**ADDENDUM NO. 2 AGRICULTURAL IMPROVMENTS FOR
LA VILLA INDPENDENT SCHOOL DISTRIC
LA VILLA, TEXAS**

DATE: **November 13, 2018**
PRIOR TO GENERAL CONSTRUCTION PROPOSAL OPENING

ADDENDUM #2

Architect: ROFA ARCHITECTS
Project Name: ARGICULTRAL IMPROVEMENTS
FOR LA VILLA INDEPENDANET SCHOOL DISTRICT
Project Number: 18.3.31
Date: 11/13/2018

AP1.1

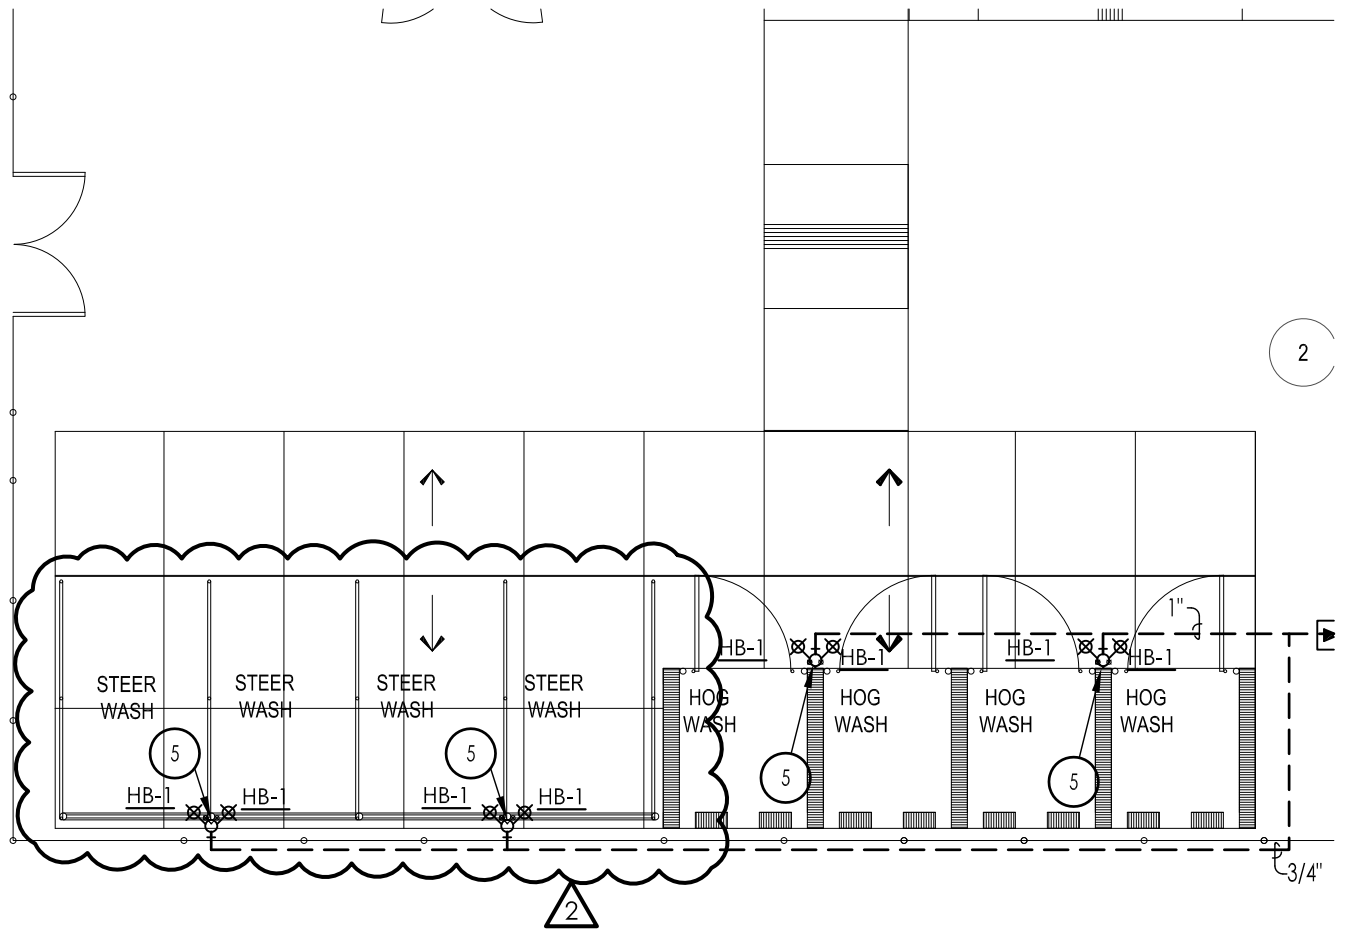
- I. Specifications:
- II. General: N/A
- III. Mechanical:
- IV. Electrical:
- V. Plumbing:
 - A. Sheet AP1.1 – Relocate hose bibs to west side of steer wash. Refer to attached.
 - B. Sheet AP2.1 – Detail#4 Adjust the Height of the hose Bibbs to 36". Refer to attached.
- VI. Fire Protection: N/A
